ASR Pipeline Cathodic Protection System Replacement

Solicitation Number: CO-00619

ADDENDUM 2

October 26, 2023

SAN ANTONIO WATER SYSTEM ASR PIPELINE CATHODIC PROTECTION SYSTEM REPLACEMENT	SCALE 1" = 50'
	SEGMENT IV PLAN (STA 254+00 TO 282+00)	DRAWING NUMBER P-10
		SHEET NUMBER 19 of 84

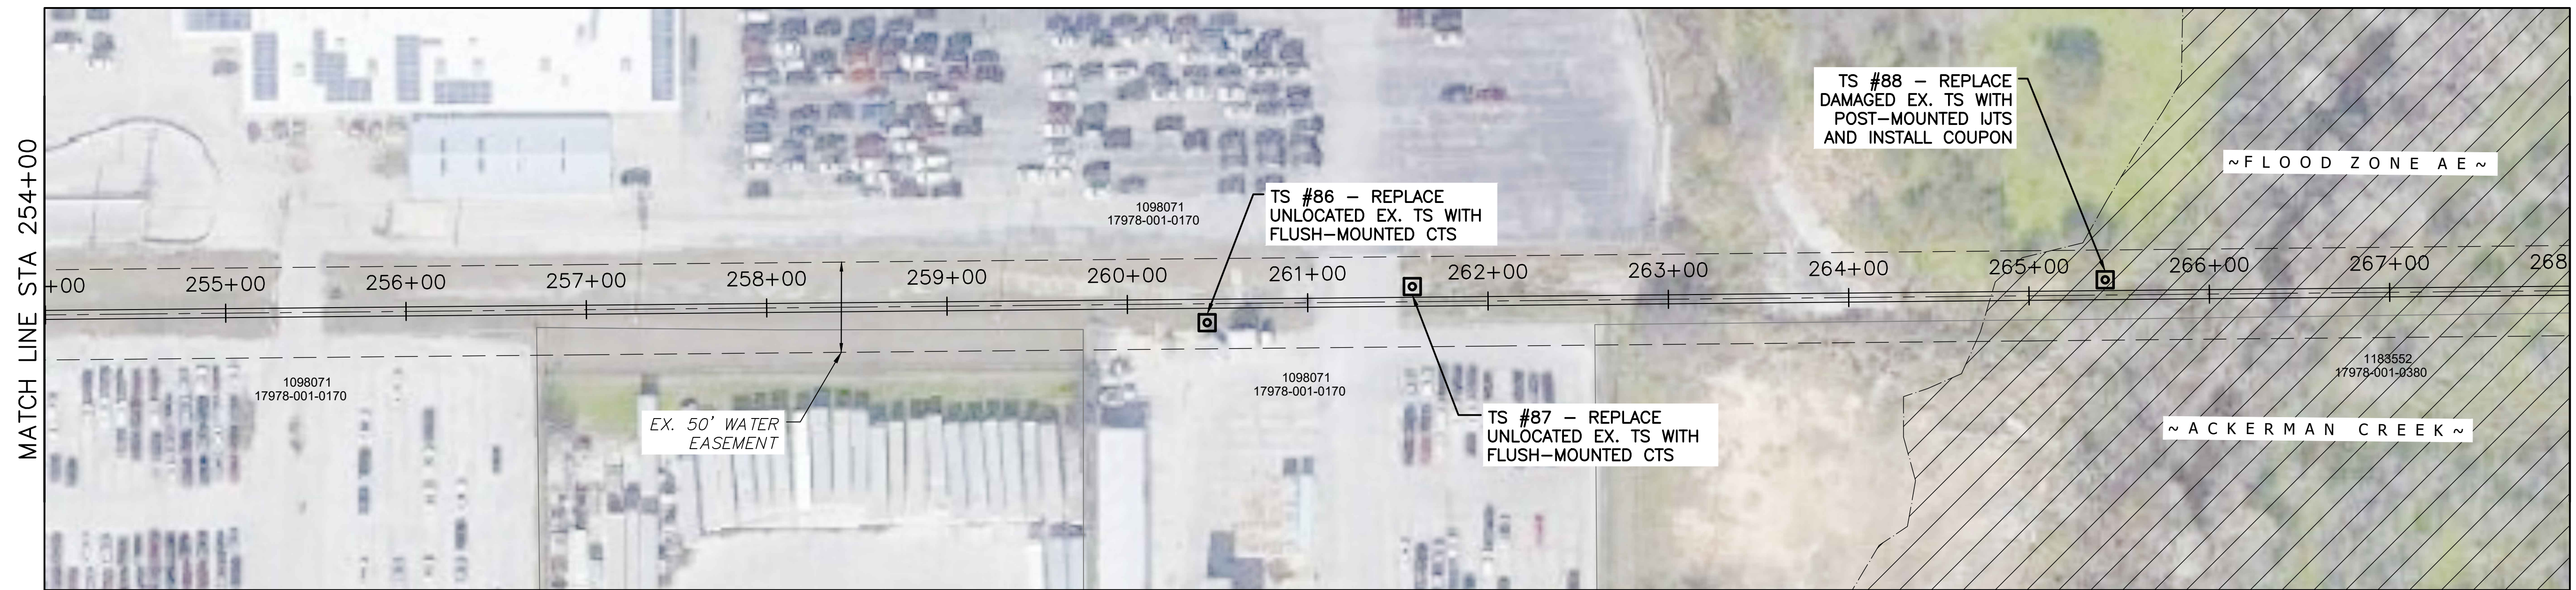
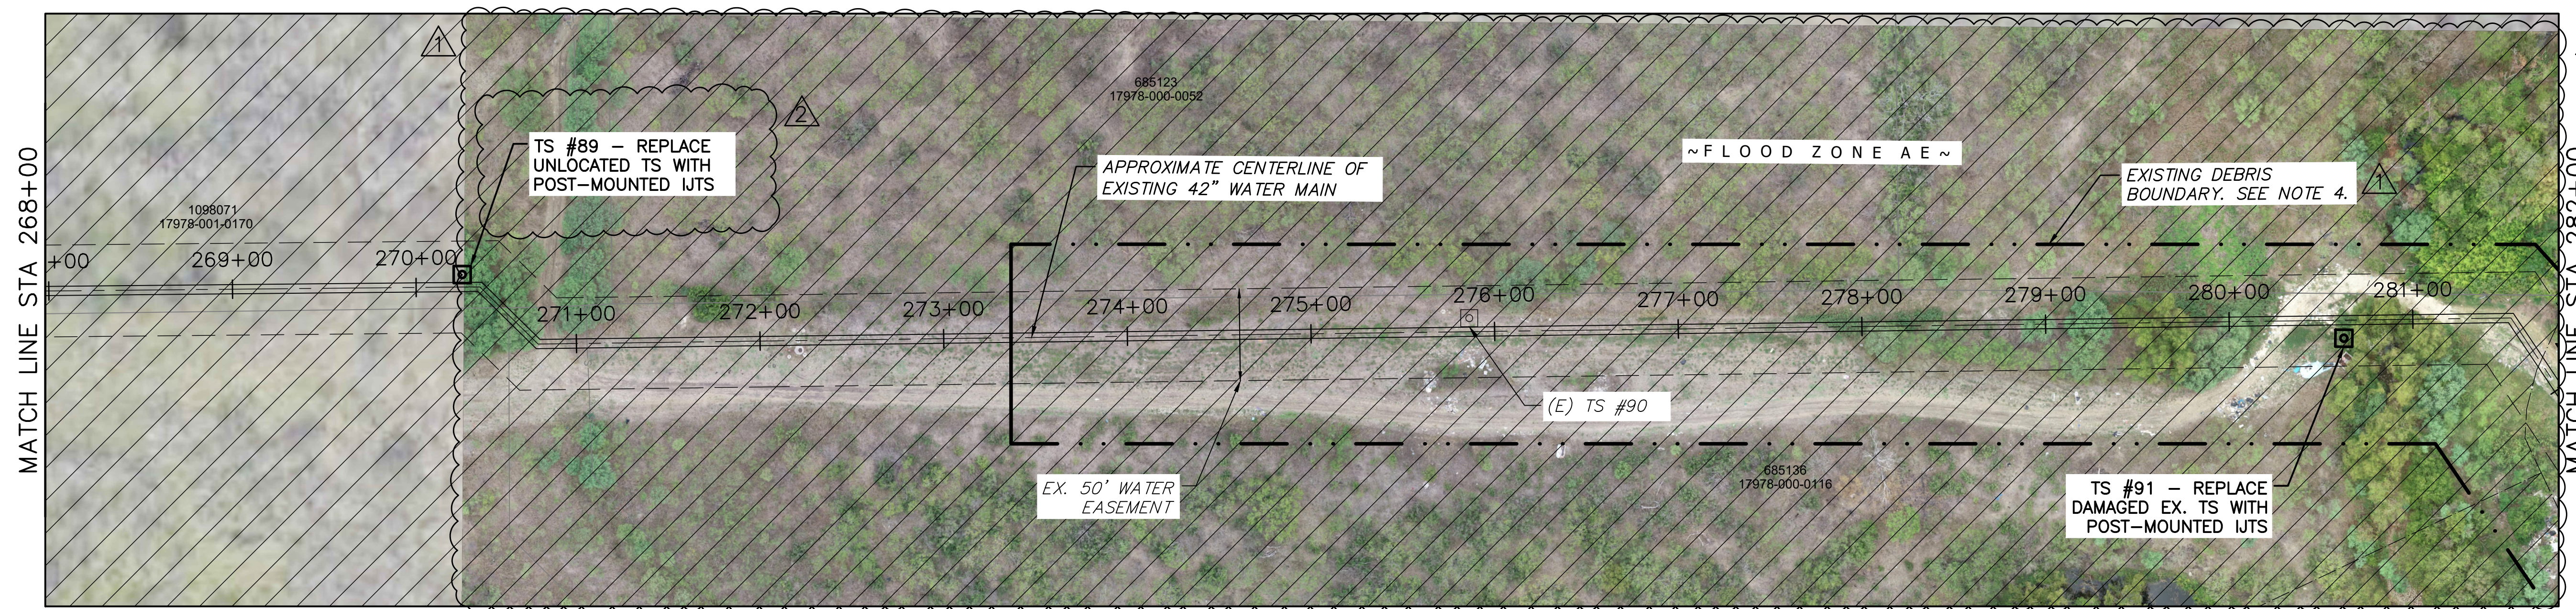
Response: It is understood this question applies to drawing number CP-1. Test Station #50 will not be modified under this project. Please refer to “Changes to the Plans”, item 4 in this Addendum.
- 5. Question: Page 44 of CO_00619_ASR CP System Replacement Plan SS, TS 89 reads, “REPLACE UNLOCATED FLUSH-MOUNT TEST STATION WITH NEW POST MOUNTED TEST STATION,” but page 19 of the same document reads “TS #89 – REPLACE EX. TS WITH POST-MOUNTED IJTS.” Do we know if the test station is unlocated or located?**

Response: It is understood this question applies to drawing number P-10. This test station was not located in the 2019 survey. Please refer to “Changes to the Plans”, item 1 in this Addendum.

1. Sheet P-10 – Segment IV Plan (STA 254+00 to 282+00)

REMOVE and REPLACE in its entirety with attached Sheet P-10.

DRAWING NUMBER
P-11

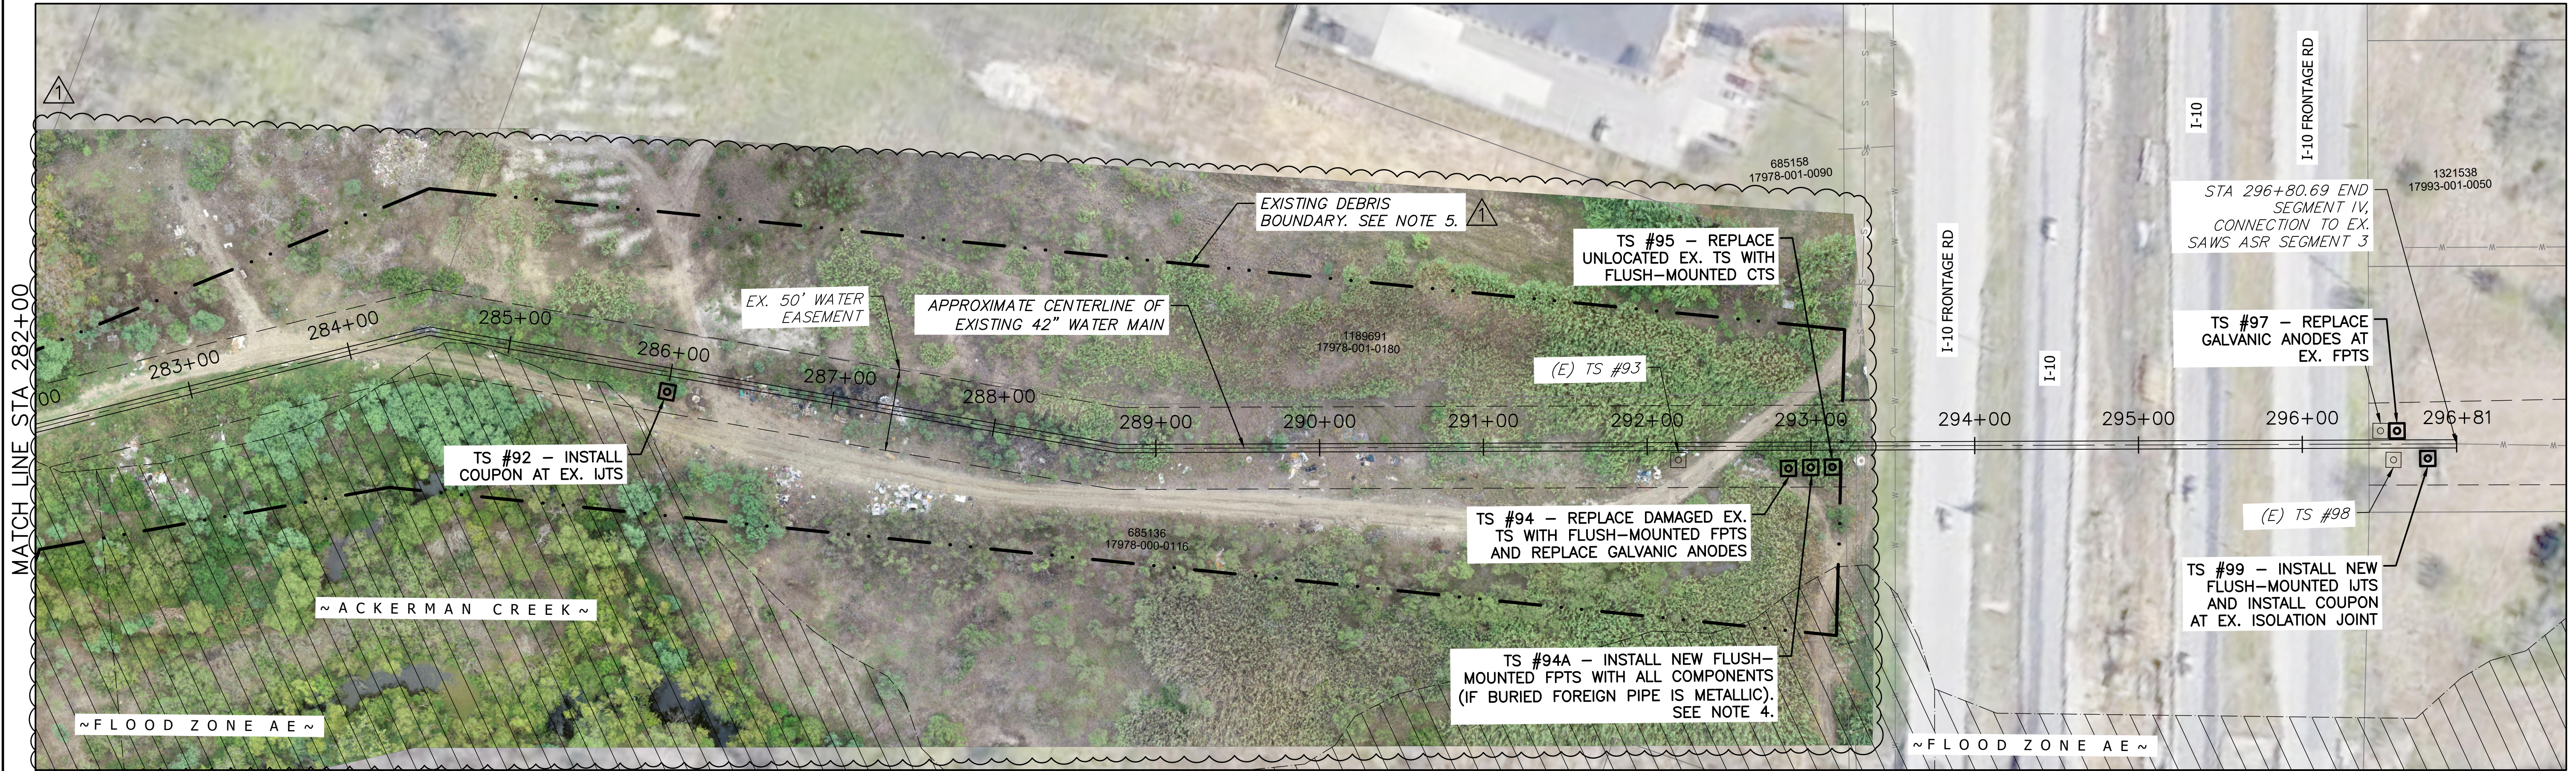
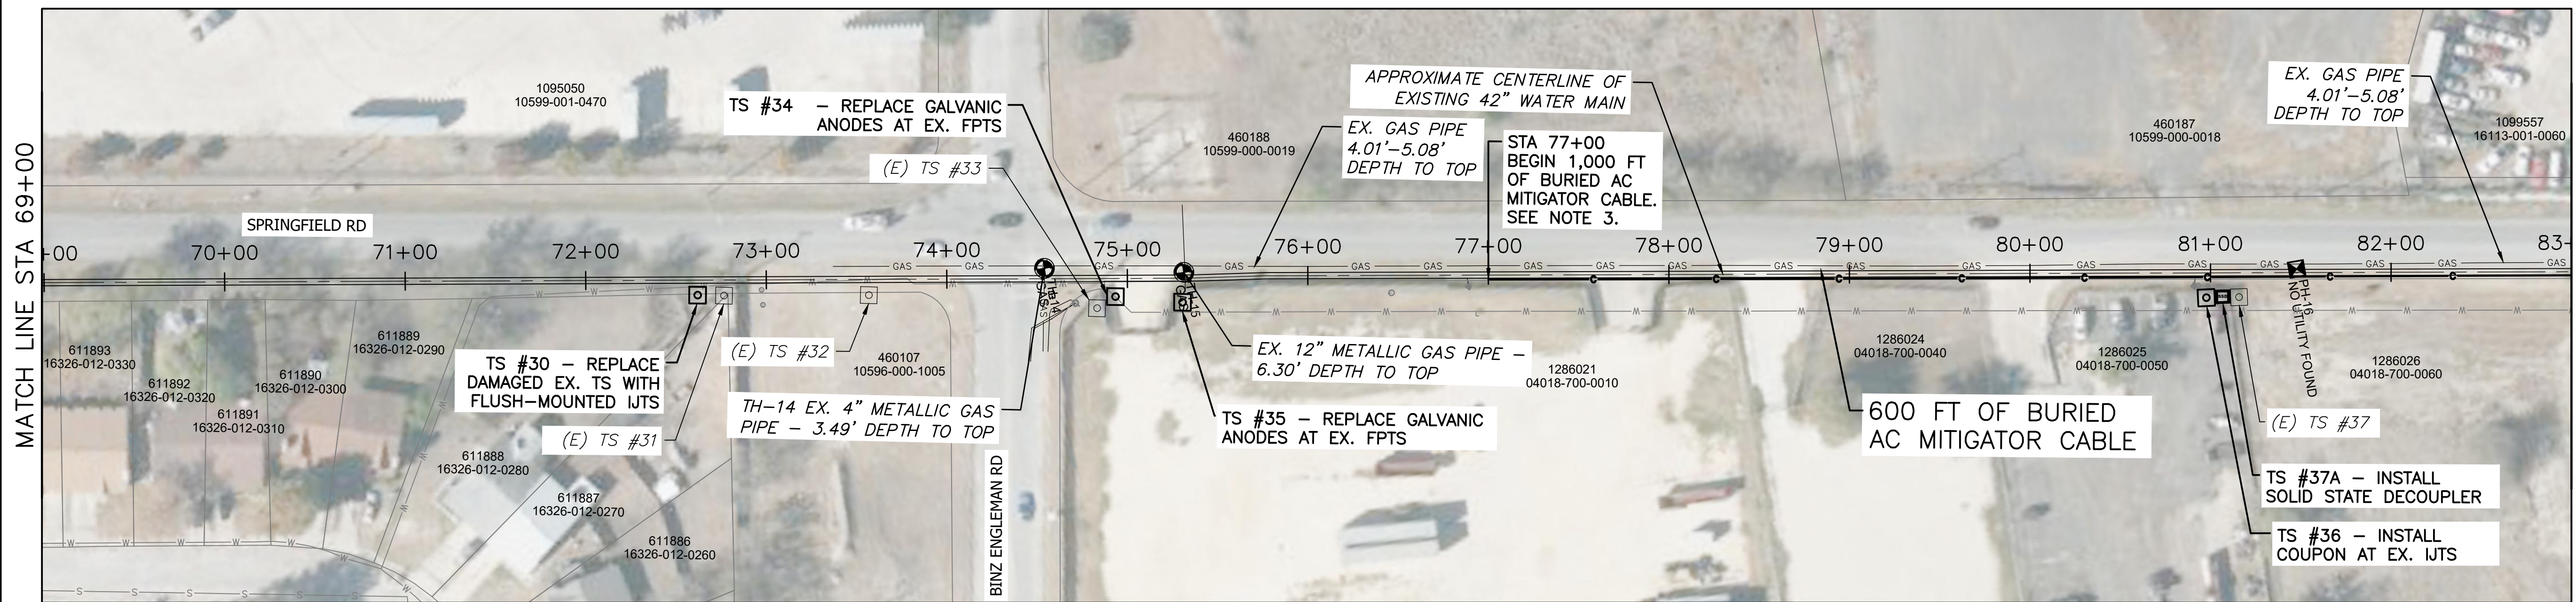
2. Sheet P-11 – Segment IV Plan (STA 282+00 to 296+81)

REMOVE and REPLACE in its entirety with attached Sheet P-11.
